Title: **QUALITY AUDIT (LRD Stage 3)**

Road Safety Audit Stage 1, Access Audit, Cycle Audit and Walking Audit.

Proposed Residential Development, Fortfield Road, Terenure, Dublin 6W.

Report reference: 1469R03

Drawing 222102-PUNCH-XX-XX-DR-C-0461 C02, Proposed Bus Stop.

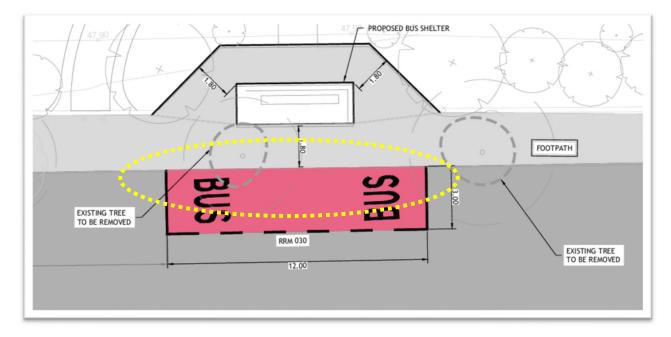
It is unclear what height kerbs are proposed at the bus stop. Low kerbs may prevent accessibility to buses for some mobility impaired pedestrians or wheelchair users. A kassel kerb detail is provided in Drawing 0550 C02 however it is unclear if this type of kerbing is intended at this location.

It is recommended that suitable height kerbs be provided to allow accessibility for all.
